CITY OF PORTLAND BUILDING PERMIT

Job ID: 2012-03-3466-ALTR

has permission to build a 16 by 20 foot deck (Single Family Residence).

Job ID: Job ID: 2012-03-3466-ALTR - raised deck & sliding glass door

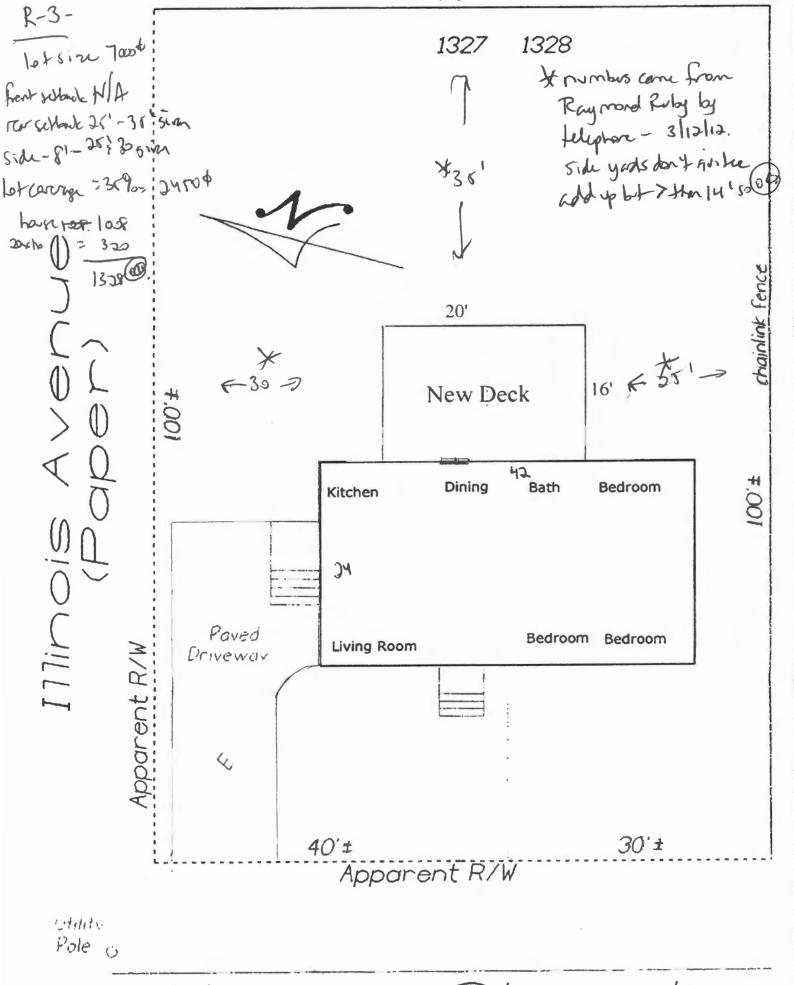
Stairs 36" wide

Frost protection -4' fint

Girders most be 2. 2x12's

for an 8' span

The girder most be

scredil together
